Groundwater Application Review Summary Form

Application # G- 18732

PUBLIC INTEREST REVIEW FOR GROUNDWATER APPLICATIONS

SUBJECT: Application G- 18732 Supersedes review of _____
Date of Review(s)

Hydrographs

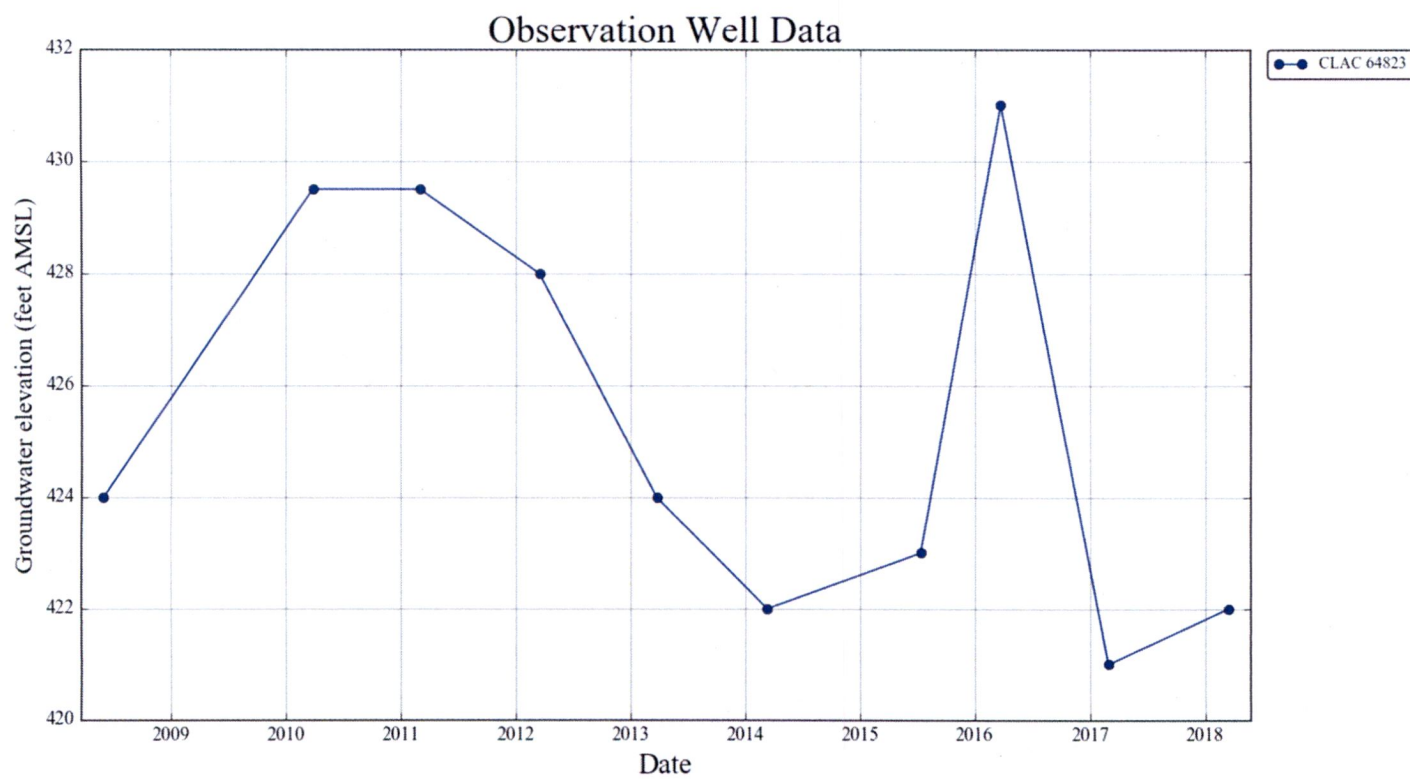
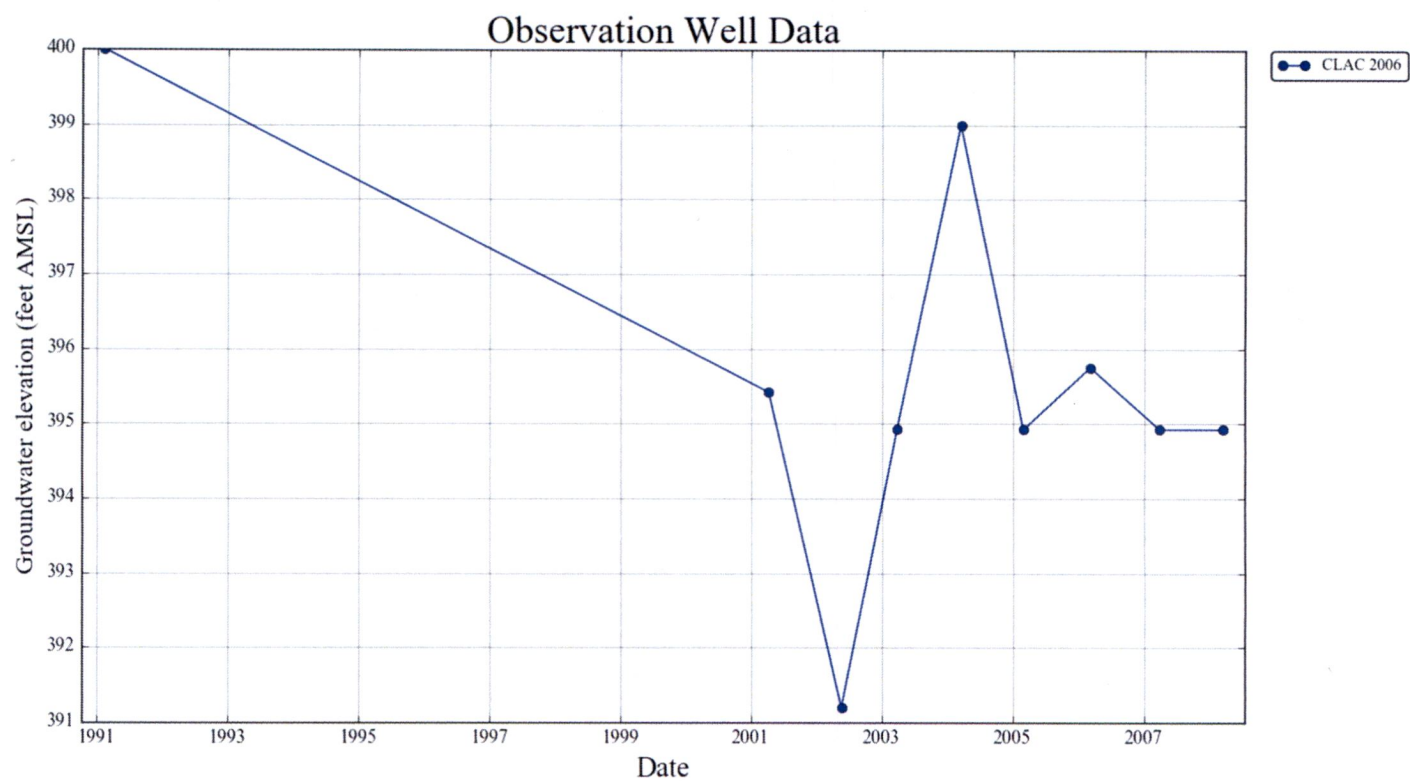
Water level data is sparse around the POA. The nearest observation wells with potentially applicable water level data (CLAC 2006 and CLAC 64823) are greater than 11,800 ft from the POA (see Hydrographs, attached). While CLAC 64823 does show an apparent declining trend of ~0.5 ft/yr on average, CLAC 2006 does not show a declining trend in recent years. It is also unclear whether CLAC 2006 and CLAC 64823 may be completed in different, hydraulically-distinct water-bearing zones from the POA, due to the seemingly discontinuous nature of the water-bearing sands and gravels. Bulk well report statistics from water wells completed in the same or adjacent quarter-quarter sections as the POA were also analyzed (see Well Statistics – Adjacent QQ, attached). These statistics do not show trends which would indicate declining water levels over time. **As such, at this time, it cannot be determined whether the proposed use will or will not be available within the capacity of the resource. It is recommended, therefore, that the permit be conditioned as specified in B(1)(d)(i) above.**
